Report to the Future Melbourne (Planning) Committee

**Ministerial Planning Referral: TPM-2017-11/A
3-43 Waterfront Way, Docklands**

4 February 2020

DELEGATE REPORT**MINISTERIAL PLANNING REFERRAL**

Figure 5 - Proposed East Elevation. From Drawing TP300

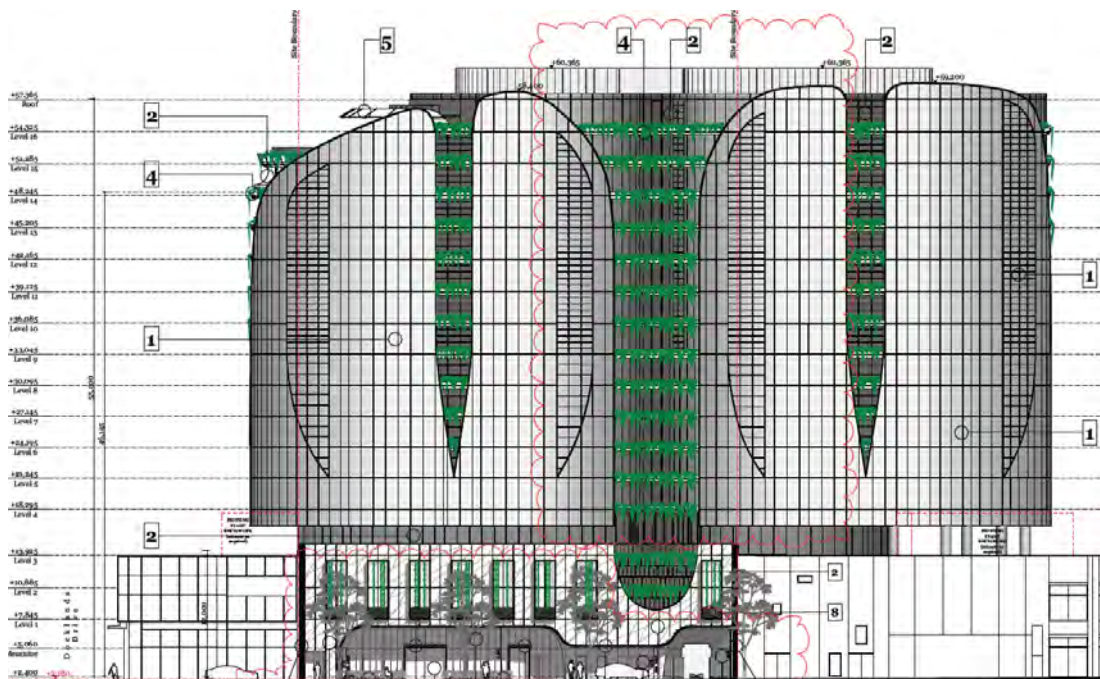
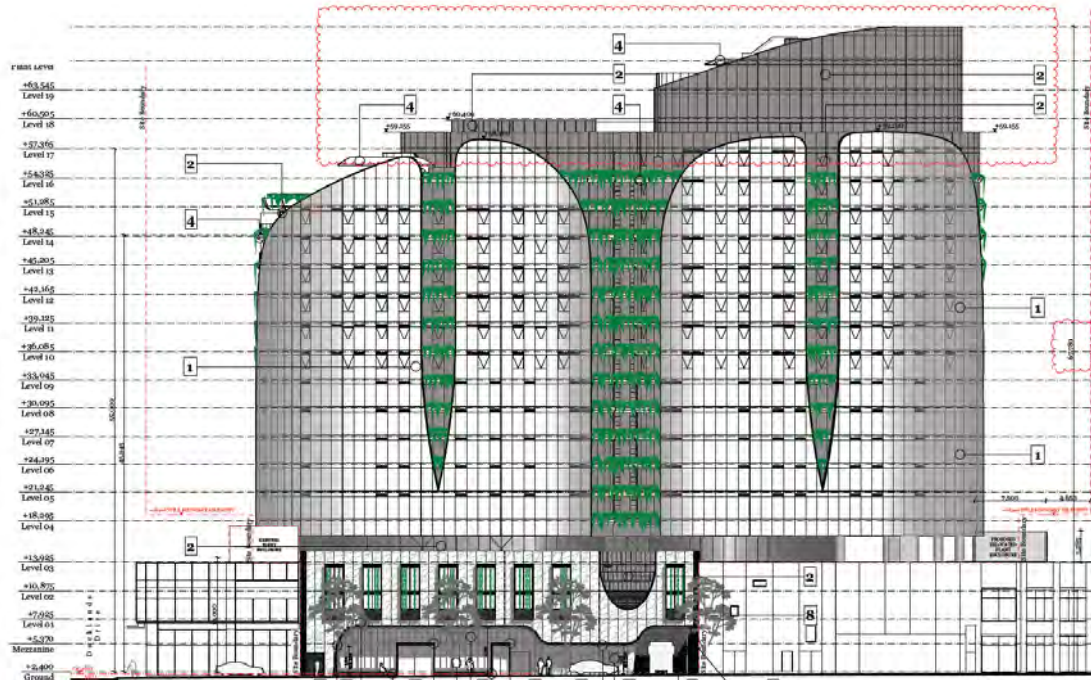
The proposal involves the addition of three levels to the approved building, taking it from RL 60.37 to RL 70.18 metres (67.8 metres above ground level). This increase in height is clearly illustrated in the below section of the proposed development.

The proposed building height is therefore consistent with the provisions of the DP Addendum, which was previously supported by Council, and is therefore considered to be acceptable.

Figure 12 - Level 18 plan. From Drawing TP215

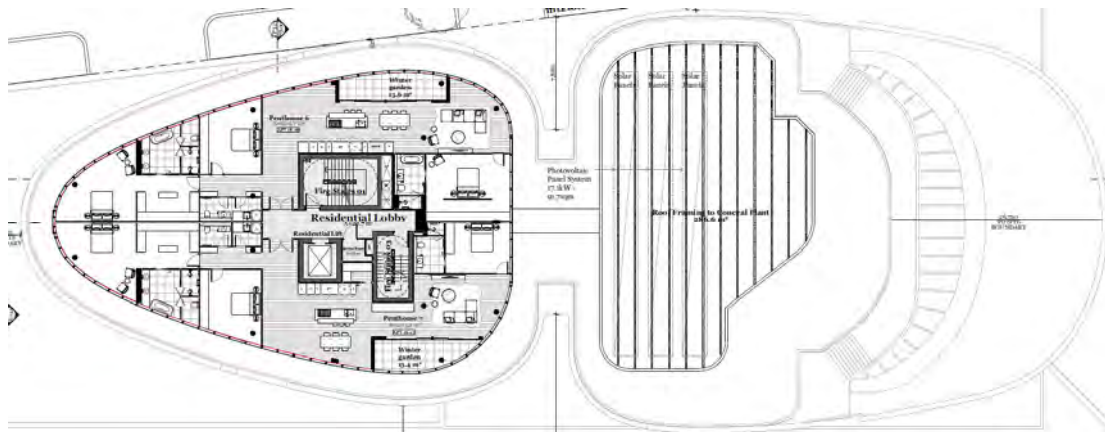
The proposal involves the addition of three levels to the approved building, which would be set back an additional 2.24 metres from all site boundaries. As the approved development is partially built to Waterfront Way, the new levels would be set back 2.24 metres from the street frontage.

The approved DP Addendum stipulates that any building on the subject site must be setback ten metres from Docklands Drive and five metres from all other boundaries. A building's street wall can, however, encroach into this setback for up to 70 per cent of this frontage. Given the site's 92 metre frontage above ground level, the five metre setback can be reduced for a length of 64.4 metres along Waterfront Way.

In terms of technical compliance, the minimum 2.24 metre setback to Waterfront Way, which quickly tapers away in excess of five metres, would not contravene the provisions of this control.

Having regard to the built form objectives and guidelines, Council's Urban Designer noted some concern in relation to the setback of the additional levels, and would prefer a five metre setback to Waterfront Way to reduce the building's impact on the streetscape.

Although the 2.24 setback is less than half of that preferred by Council's Urban Designer, it nevertheless creates a clearly distinguishable transition in the building that is located behind the prominent 'skin' of the façade on lower levels. As the proposal involves an additional 9.61 metres of built form above the existing building, it is considered that the proposed setbacks provide adequate relief when these additional levels are viewed from the surrounding streetscape.

Given the above, it is considered that the proposed setbacks of the additional levels are acceptable.

Figure 10 - Extract from the Development Plan Addendum referred to in the approval

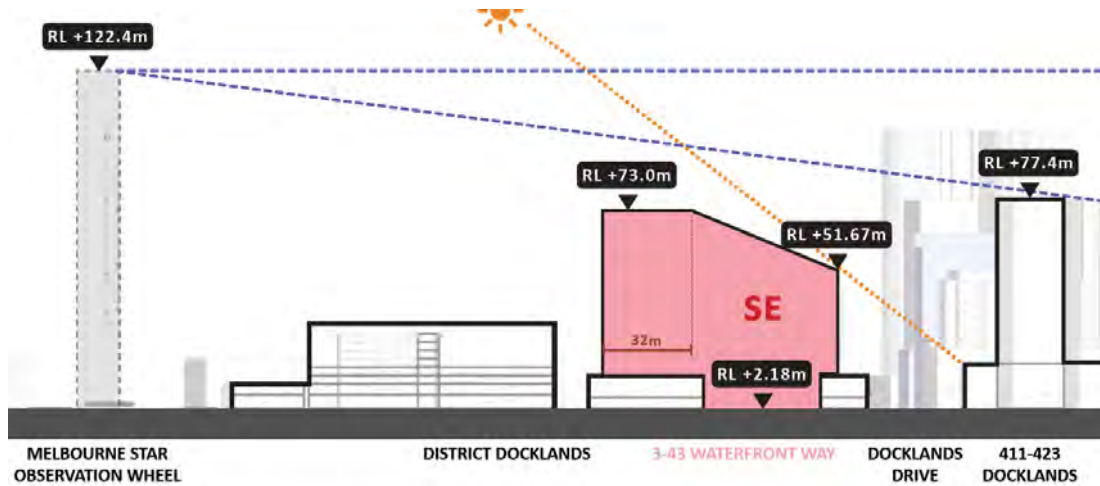
Although this height significantly exceeds the 45 metre discretionary maximum building height of the applicable DDO54; the approved DP Addendum allows for a maximum height of RL 73 metres, which tapers down to RL 51.67 towards the southern boundary of the site (see below). Importantly, the conditions of the DP Addendum approval do not vary the building envelopes depicted in the submitted document.

Figure 15 - Shadow Study extracts depicting additional overshadowing at 12noon on the Winter Solstice.

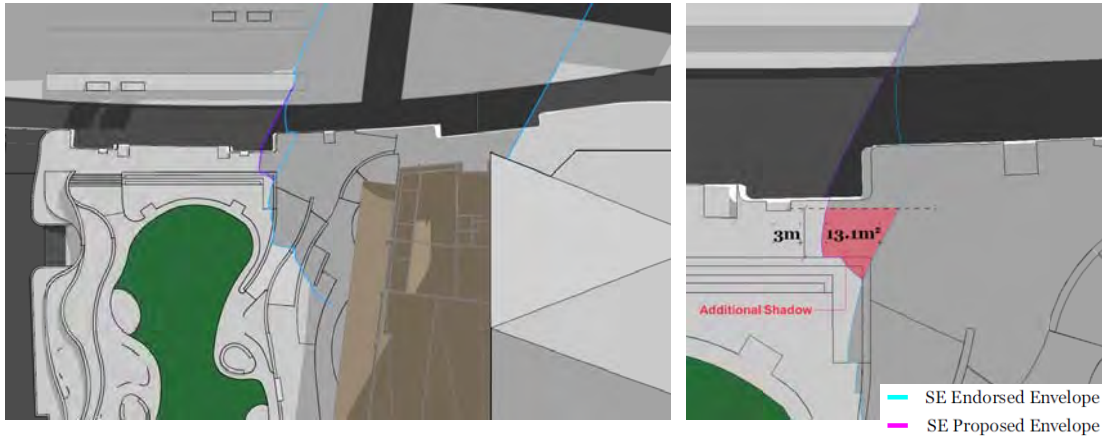
The submitted overshadowing diagrams demonstrate that the amended design would result in a small area of additional overshadowing on the footpath (approximately 13m²) on the southern side of Docklands Drive (refer to Figure 15 below).

It is the permit applicant's submission that the small area of additional overshadowing is 'generally in accordance' with the approved development.

Having regard to relevant Planning Scheme Policy, and the views of Council's Urban Designer, it is considered that the extent of additional overshadowing is acceptable for the following reasons:

- The additional overshadowing covers a relatively small portion of the footpath.
- NewQuay Central Park itself would not be subject to any additional overshadowing at any time of the year.
- Additional overshadowing would be restricted to 12 noon, with no additional overshadowing occurring from 9 to 11am or again from 1pm to 3pm.

Figure 16 - Marked up site photo depicting approximate extent of additional overshadowing at 12noon on the Winter Solstice in purple shading.

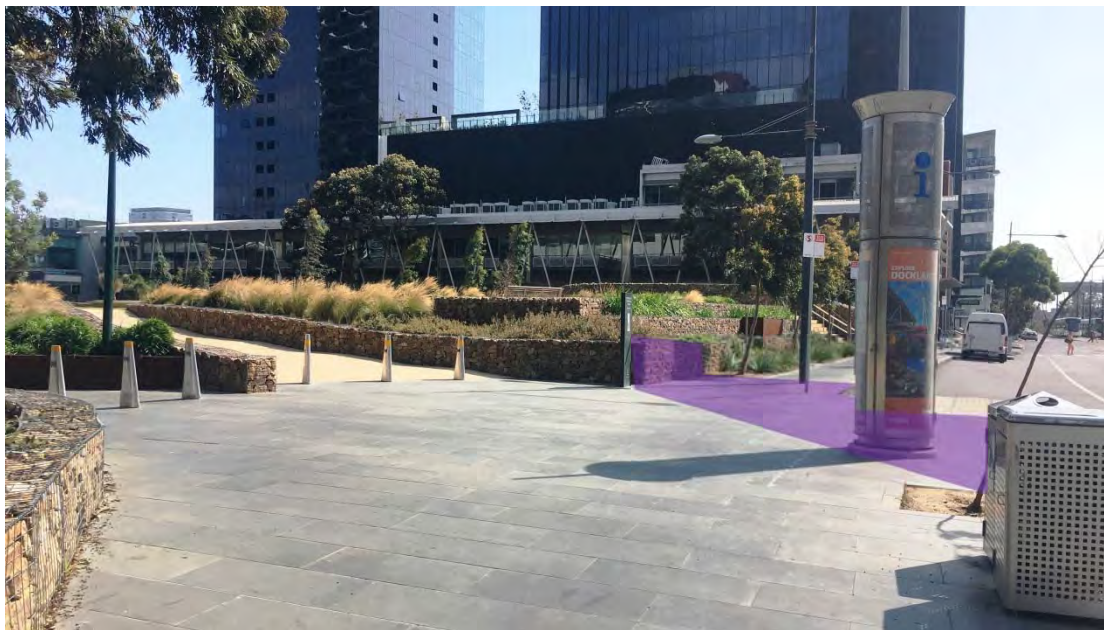
The approximate area which would receive additional overshadowing at 12 noon on the Winter Solstice is depicted in the site photo in Figure 16 below.

Figure 17 - Extract from Acoustic Logic report setting out minimum glazing requirements for Level 17 of the proposed development

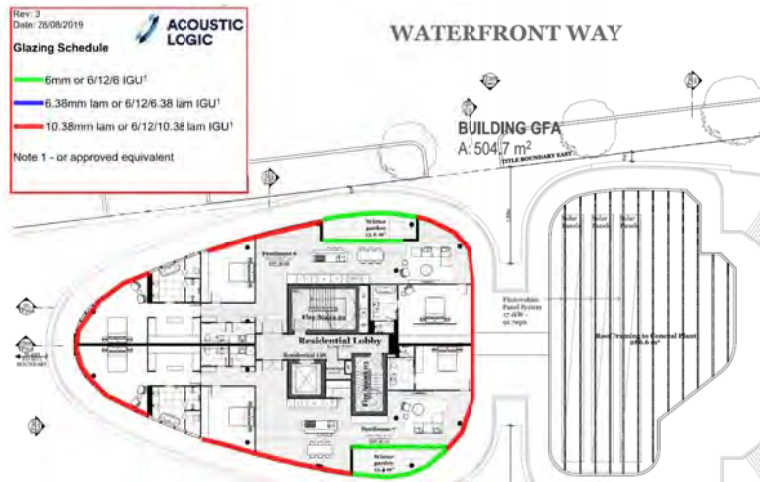
An amended Acoustic Report, dated 28 August 2019, was submitted as part of the planning application. The report sets out minimum glazing requirements for the additional levels to achieve compliance with the condition (refer to the example on the following page).

The submitted Architectural Drawings do not nominate the types of glazing proposed and should therefore be updated to reflect these requirements.

1. Prior to the commencement of the development, an amended set of plans drawn to scale, must be submitted to the Responsible Authority generally in accordance with those as received with the application but amended to show:
 - a) At least one bicycle space within all dwellings on levels 16-19, as shown on Drawings TP213, TP214, TP215 and TP216, Revision G.
 - b) The type of glazing for all external windows, consistent with the minimum requirements of the endorsed Acoustic Report at Condition 16.
